**CERTIFICATION AND REQUEST FOR PRIORITIZED EXAMINATION
UNDER 37 CFR 1.102(e) (Page 1 of 1)**

First Named Inventor:	Merrilee Kick	Nonprovisional Application Number (if known):	
Title of Invention:	CONTAINER

Application Data Sheet 37 CFR 1.76		Attorney Docket Number	58822.5US04
		Application Number	
Title of Invention	Container		
The application data sheet is part of the provisional or nonprovisional application for which it is being submitted. The following form contains the bibliographic data arranged in a format specified by the United States Patent and Trademark Office as outlined in 37 CFR 1.76. This document may be completed electronically and submitted to the Office in electronic format using the Electronic Filing System (EFS) or the document may be printed and included in a paper filed application.

Figure 9

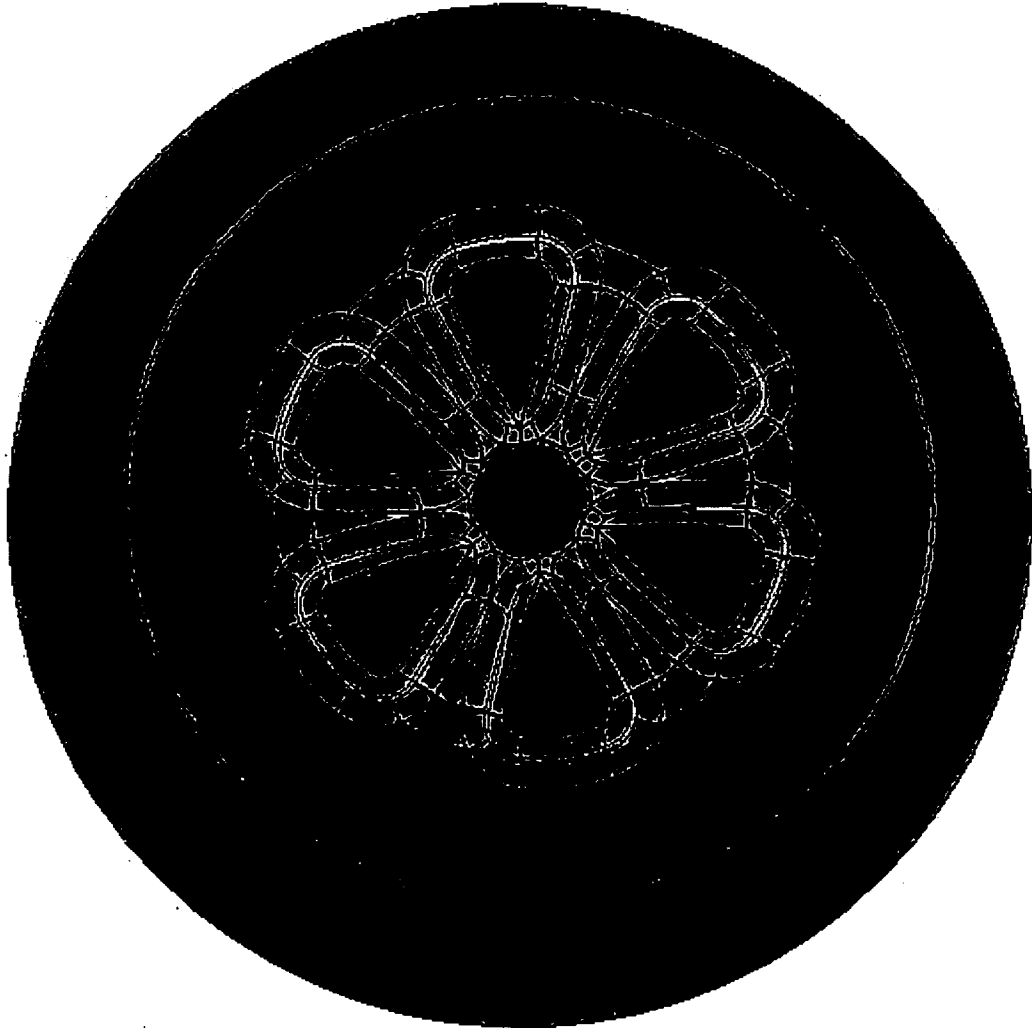
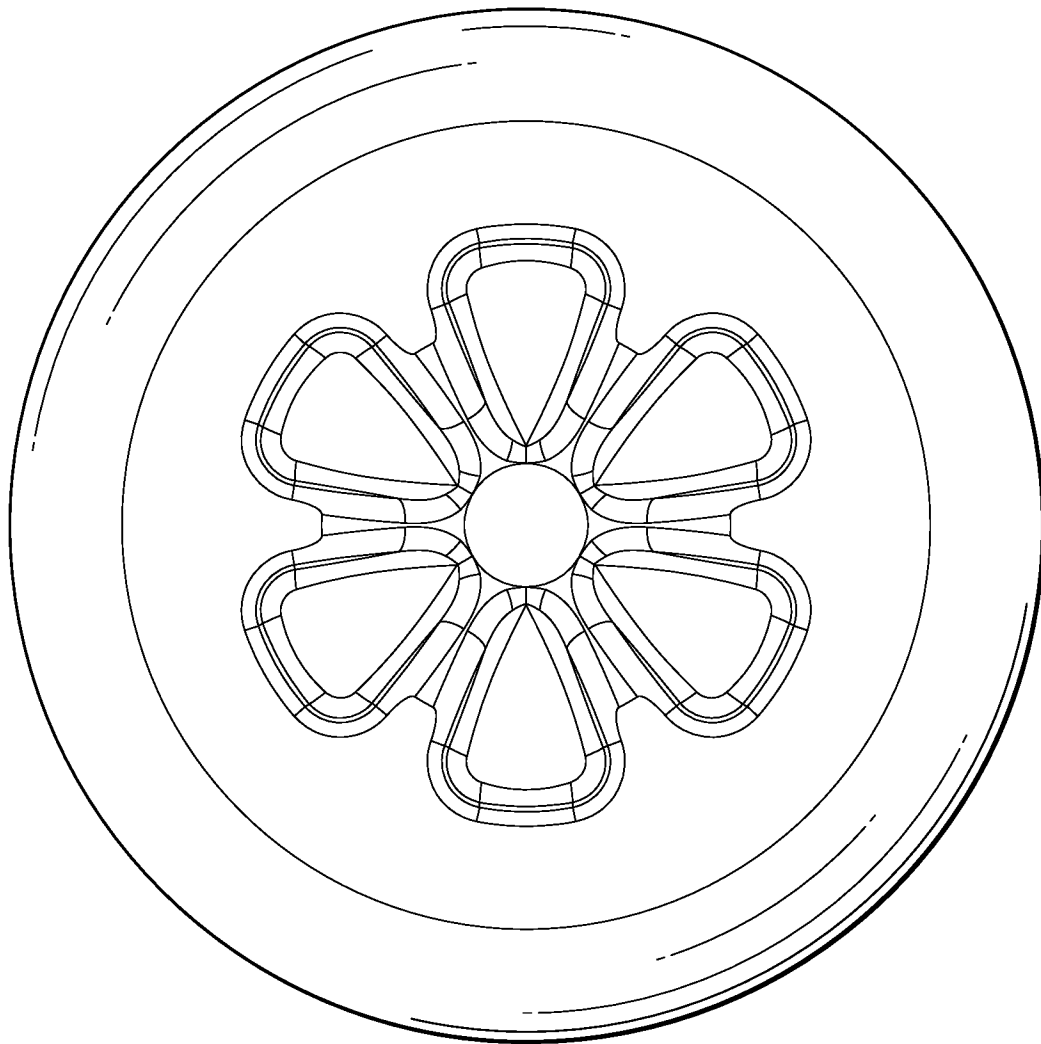
2. The drawings are objected to because Figure 9 shows the bottom of the container in a color drawing making it difficult to see the details of the bottom of the container. Corrected drawing sheets in compliance with 37 CFR 1.121(d) are required in reply to the Office action to avoid abandonment of the application. Any amended replacement drawing sheet should include all of the figures appearing on the immediate prior version of the sheet, even if only one figure is being amended. The figure or figure number of an amended drawing should not be labeled as “amended.” If a drawing figure is to be canceled, the appropriate figure must be removed from the replacement sheet, and where necessary, the remaining figures must be renumbered and appropriate changes made to the brief description of the several views of the drawings for consistency. Additional replacement sheets may be necessary to show the renumbering of the remaining figures. Each drawing sheet submitted after the filing date of an application must be labeled in the top margin as either “Replacement Sheet” or “New Sheet” pursuant to 37 CFR 1.121(d). If the changes are not accepted by the examiner, the applicant will be notified and informed of any required corrective action in the next Office action. The objection to the drawings will not be held in abeyance.

The attached Replacement Sheet including Figure 9 replaces the original sheet including Figure 9.

FIG 2

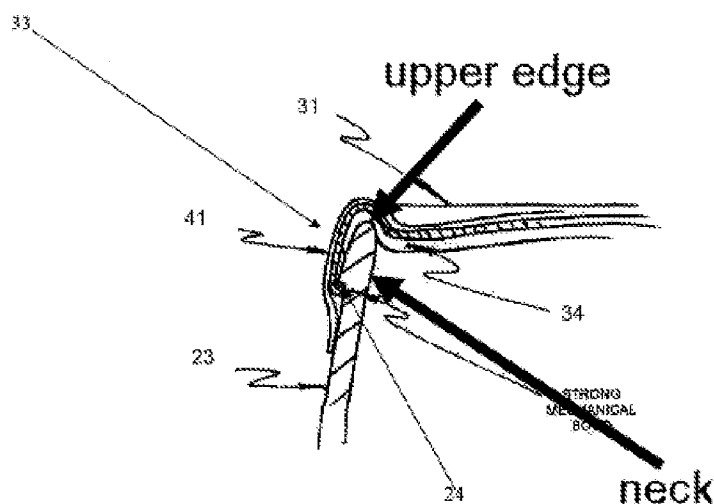
This figure, now referred to as Wing annotated Fig. 2, used for the rejection of claims 6-12 has been replicated below, and the Examiner has added reference points for ease of explanation, and said reference points will be used for the rejection of claims 6-12 below.

As to claim 6, Wing teaches a container, comprising: a container body (glass 20), said container body defining a first opening (pg. 13, lines 23-25) to an interior of said container body; and a lid (lid 30) connected to the container body and covering the first opening to the interior of said container body (pg. 13, lines 27-29); wherein the container body is made out of a resin (pg. 7, line 31-pg. 8, line 1); wherein the lid is made out of a metal (pg. 13, line 30); wherein the container body comprises a container side wall (container portion 23) and a horizontally-extending portion (bottom, Wing annotated Fig. 103) connected to the container side wall (Wing annotated Fig. 103); wherein a cross-sectional diameter of the first opening to the interior of said container body is less than a cross-sectional diameter of a middle portion of said container body (Fig. 2 shows

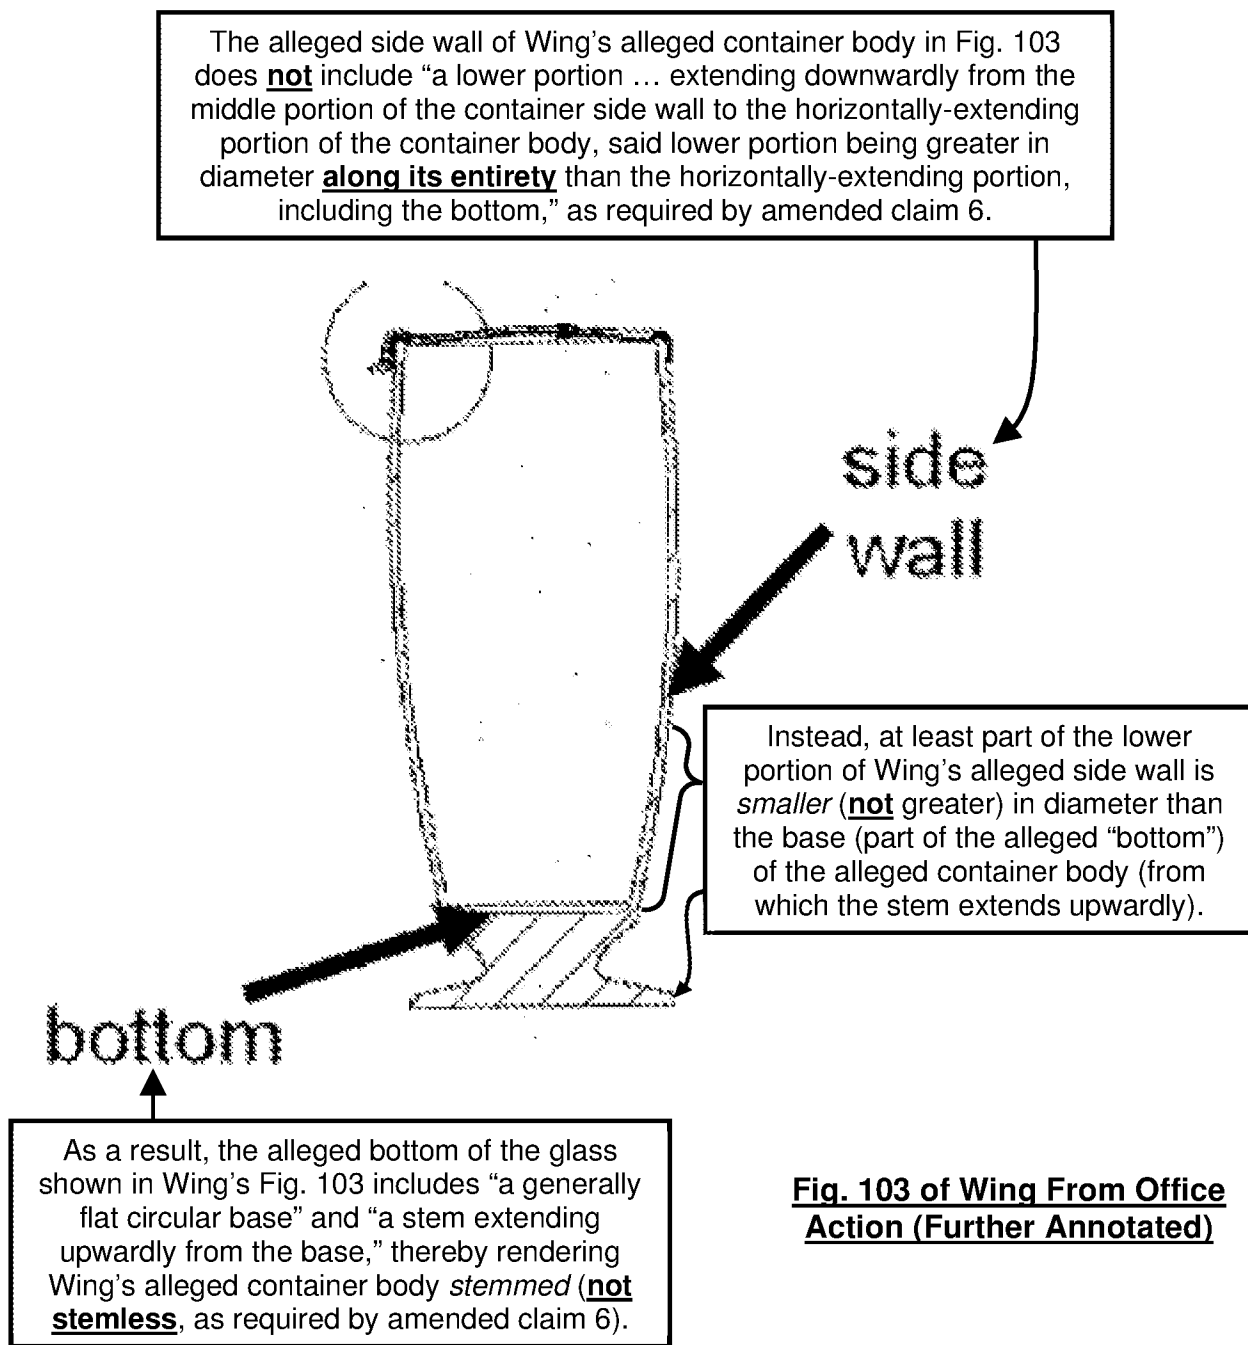
On page 7, the Office Action maps the terms “side wall” and “bottom” to Fig. 103 of Wing, alleging that Wing anticipates claim 1.

However, contrary to the subject matter of amended claim 6, the alleged bottom of the glass shown in Wing’s Fig. 103 includes “a generally flat circular base” and “a stem extending upwardly from the base,” thereby rendering Wing’s alleged container body *stemmed* (**not** stemless). See Wing, page 8, lines 8-9. **Much less** does the alleged side wall of Wing’s alleged container body in Fig. 103 include “a lower portion ... extending downwardly from the middle portion of the container side wall to the horizontally-extending portion of the container body, said lower portion being greater in diameter **along its entirety** than the horizontally-extending portion, including the bottom,” as required by amended claim 6. Instead, at least part of the lower portion of Wing’s alleged side wall is *smaller* (**not** greater) in diameter than the base (part of the alleged “bottom”) of the alleged container body (from which the stem extends upwardly).

Fig. 103 of Wing, as annotated by the Examiner on page 7 of the Office Action, is reproduced below with further annotations to support Applicant's arguments in this regard.

As shown above, Wing fails to disclose each and every element of amended claim 6 in sufficient detail to support an anticipation-based rejection of this claim.
